**Subject: Notification of Piezometer DHR Abandonment, Revised
Richmond Field Station, UC Berkeley**

**SUBJECT: REVIEW OF NOTIFICATION OF PIEZOMETER DHR ABANDONMENT,
RICHMOND FIELD STATION, UNIVERSITY OF CALIFORNIA,
BERKELEY**

**FIGURE 23
 SHALLOW GROUNDWATER
 ELEVATION CONTOURS,
 OCTOBER 5, 2020**

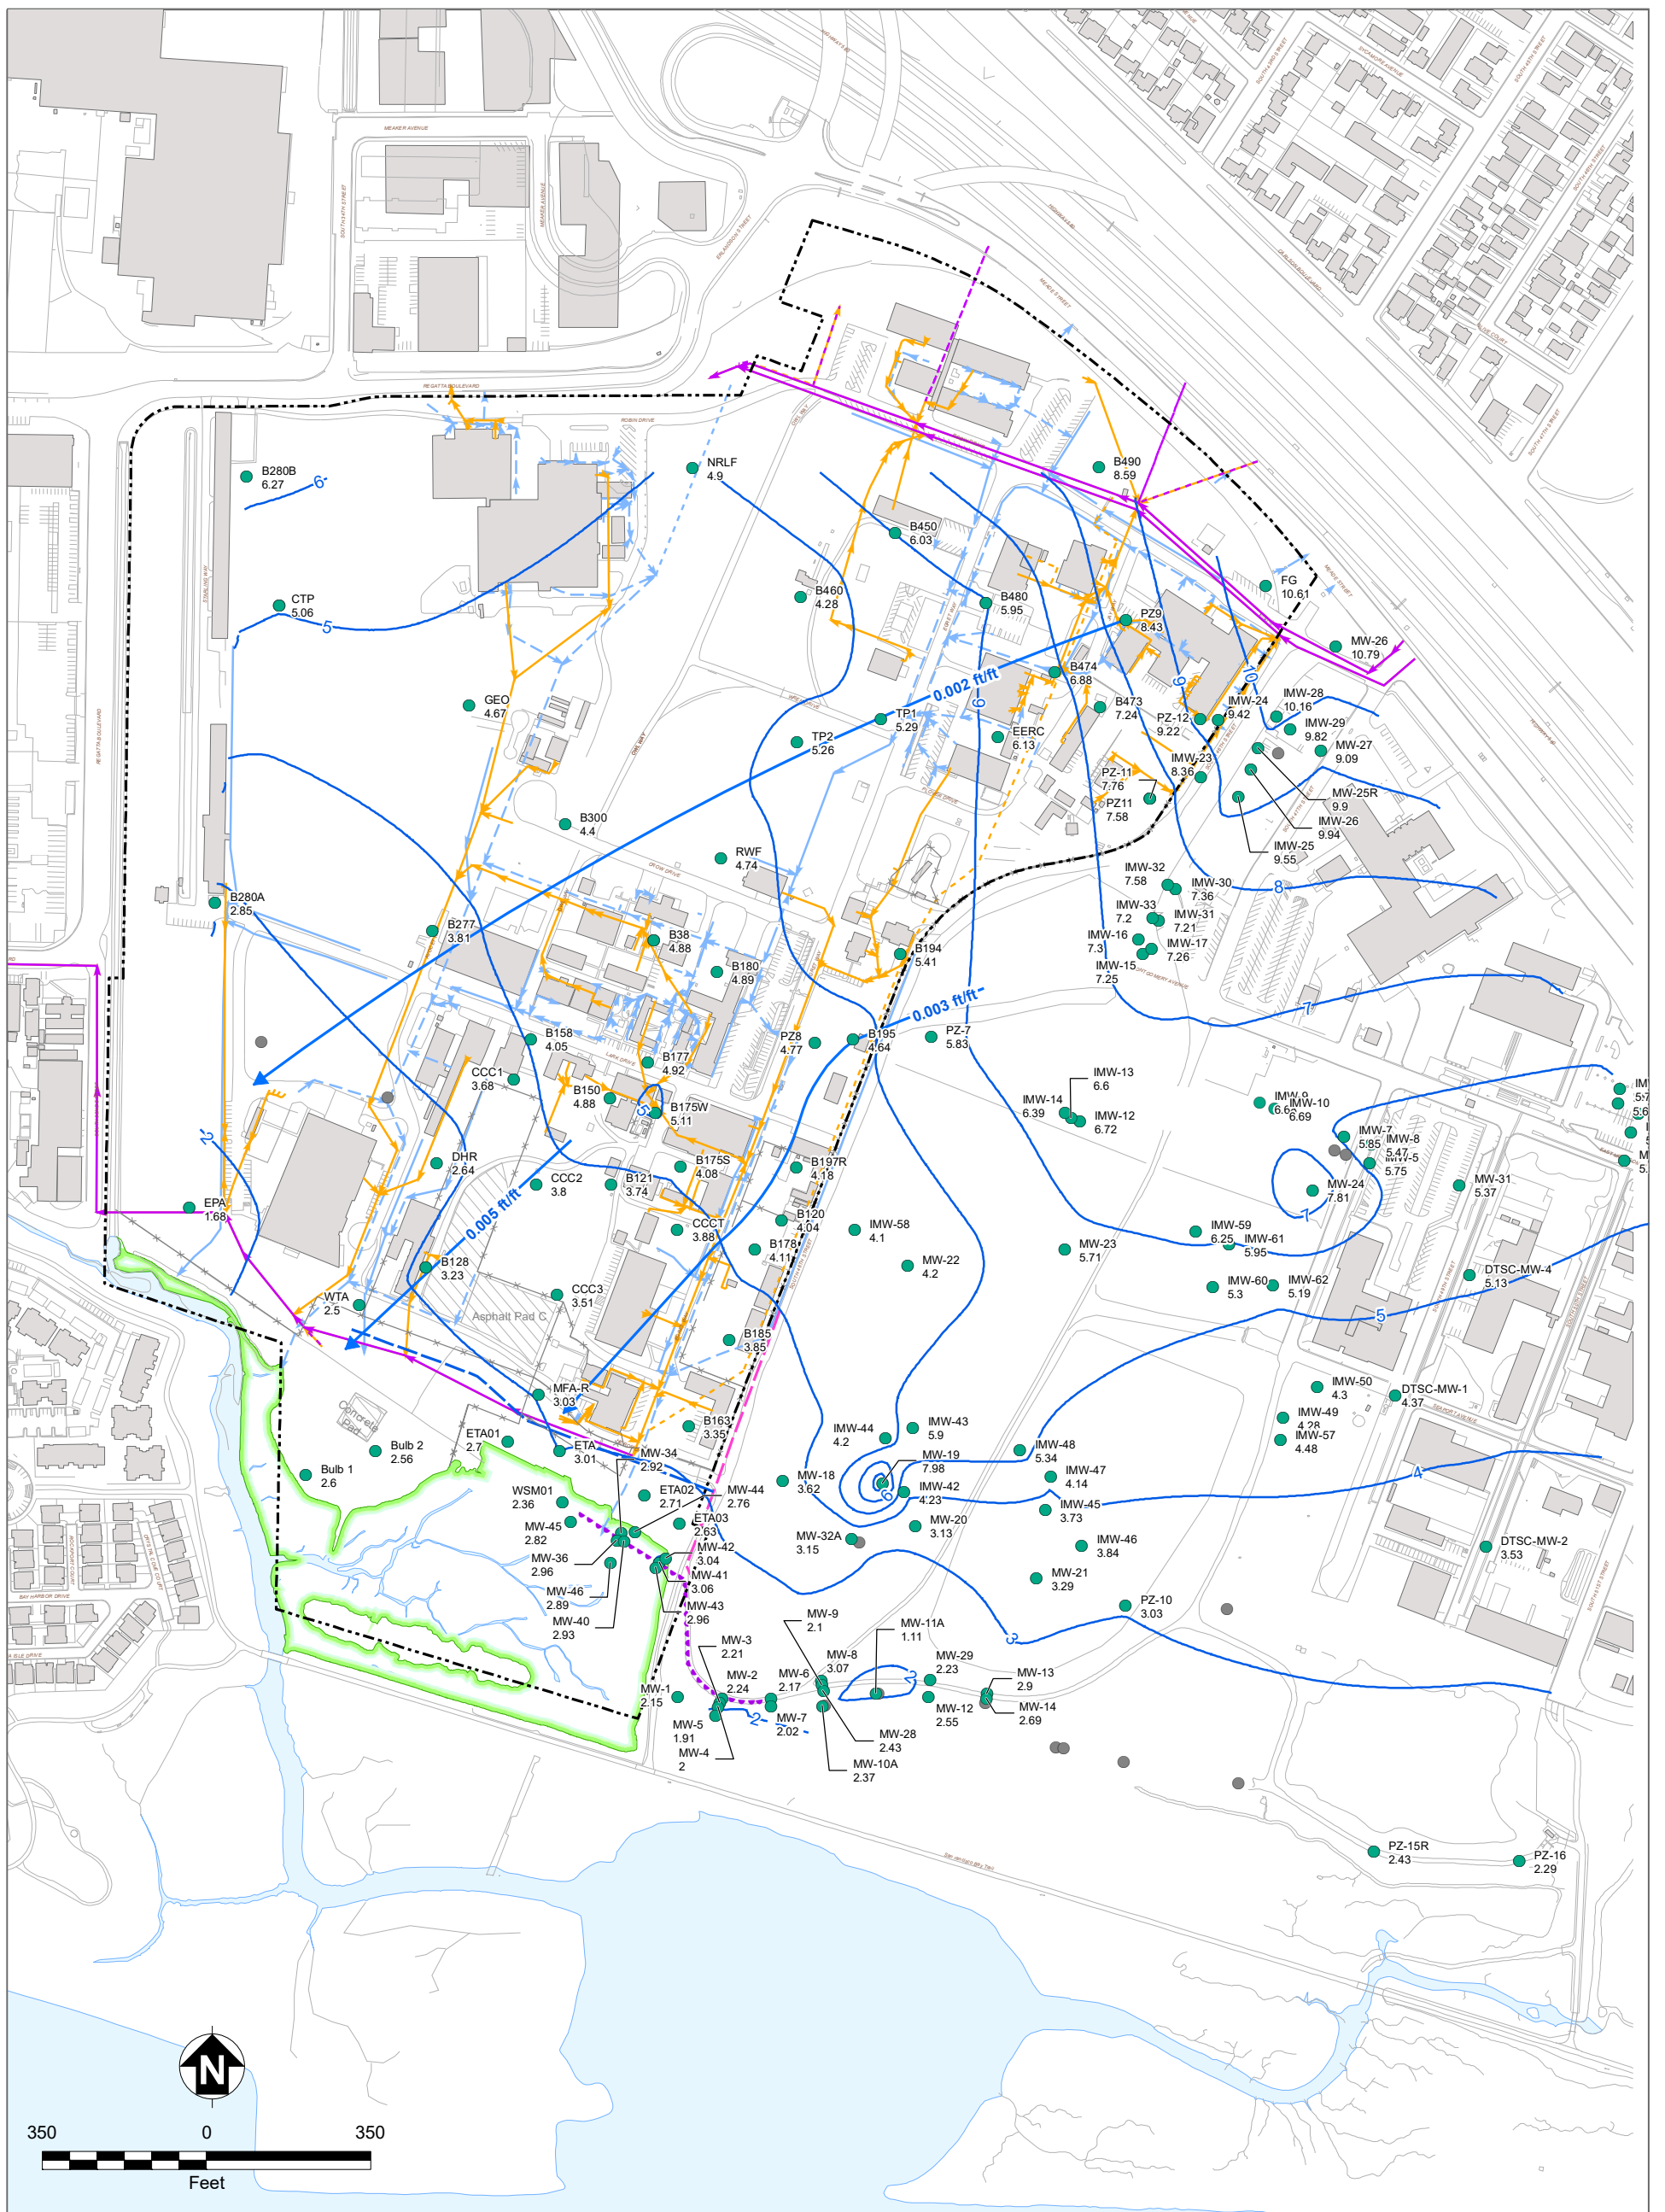
1. The second sentence of the Letter mentions a piezometer B201 being near piezometer DHR, which is not helpful in that there is no such piezometer shown on either Figure 23 or 24. Also, note that piezometer DHR is located more in the southwesterly portion of RFS than in the southeast. Please edit appropriately to more clearly describe the location.

“Results from DHR are not critical and do not impact any ongoing groundwater monitoring efforts, as DHR is surrounded by four nearby piezometers: B278 ~~B278-R~~ to the north, CCC2 to the ~~west~~ east, B128 to the south, and EPA to the ~~east~~ west.”

During the October 2022 groundwater levels monitoring event, piezometer DHR was discovered to have been destroyed by Richmond Field Station (RFS) staff inadvertently during nearby stormwater maintenance activities. DHR is located in the southwestern portion of RFS, between piezometers B278-R, CCC2, and B128. The top 2 feet of the piezometer were destroyed and removed, and the remaining portion remains in place. This letter addresses comments received from DTSC dated January 4, 2023, and replaces the original notification letter dated December 16, 2022. DTSC comments are included as Attachment A.

Results from DHR are not critical and do not impact any ongoing groundwater monitoring efforts, as DHR is surrounded by four nearby piezometers: B278-R to the northwest, CCC2 to the east, B128 to the south, and EPA to the west. All piezometers are shown on the attached figures which represent the most current wet and dry season groundwater elevation contours from the 2021 Groundwater Sampling Results, Technical Memorandum, dated June 6, 2022.
